VA Roseburg - Community Living Center Expansion – Project No: 653-321
913 NW Garden Valley Boulevard
Roseburg, OR 97471

ADDENDUM NO. 1

This Addendum forms a part of the Contract Documents and modifies the original Bidding Documents (Conformed Set) dated March 15, 2012 as noted below. Acknowledge receipt of this Addendum in the space provided on the Bid Form. Failure to do so may subject the Bidder to disqualification.

2. SHEET GS-120 – SITE PLAN

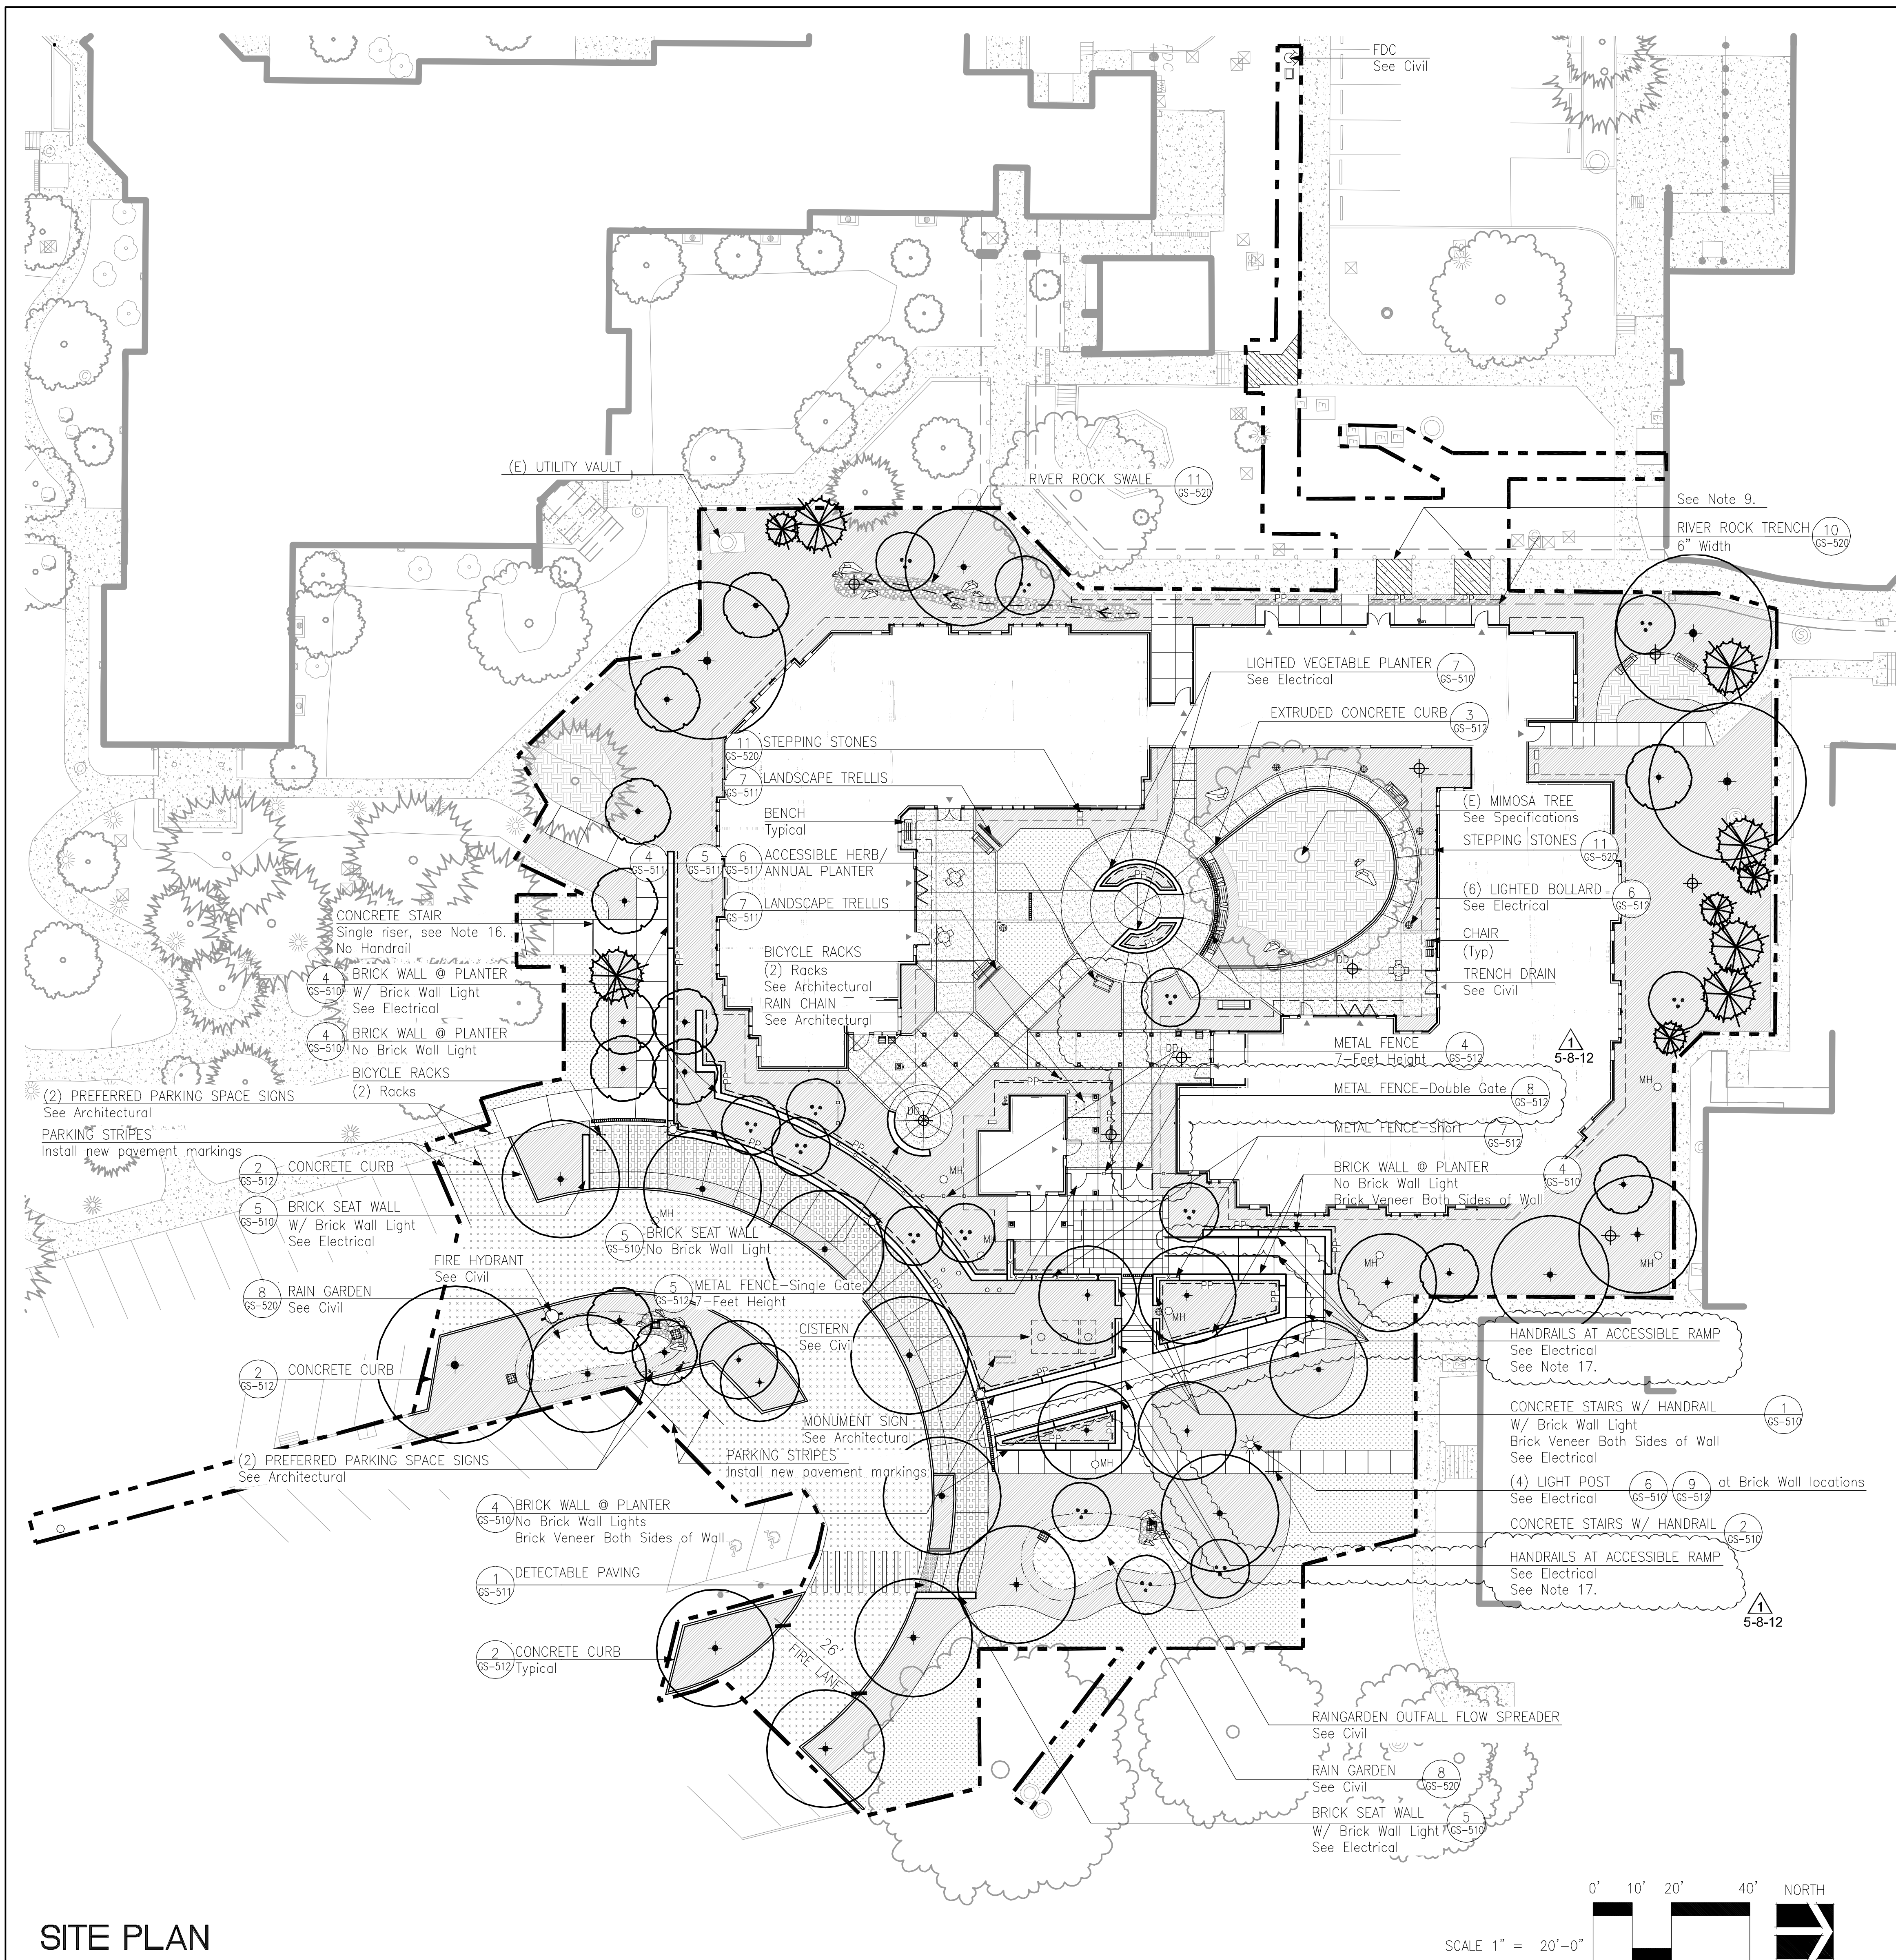
- A. Replace sheet revising the following items:
- A. Correcting detail reference at "Metal Fence – Double Gate"
 - B. Adding hand rails at accessible ramp

AD-01 - GYPSUM CEILING TRANSITION @ SOFFIT

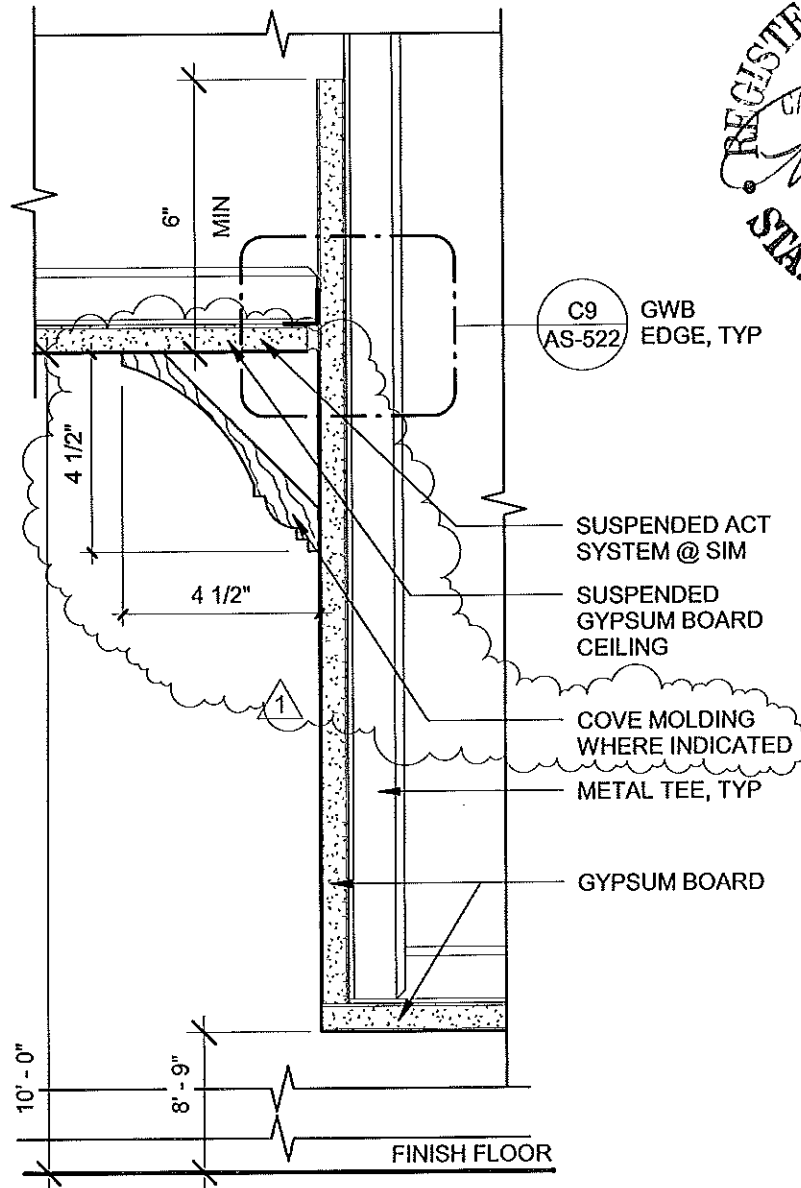
20. SHEET AS-522 – DRAWING E3

- A. Replace detail with attached detail including cove molding

- B. Change note “GLASS PANEL” to read:

CP-1 IN KITCHEN-109/ACTIVITY-106 & CP-3 IN DINING-108. APPLY OBSCURE FILM ON BACK SIDE OF CP-1 & CP-3
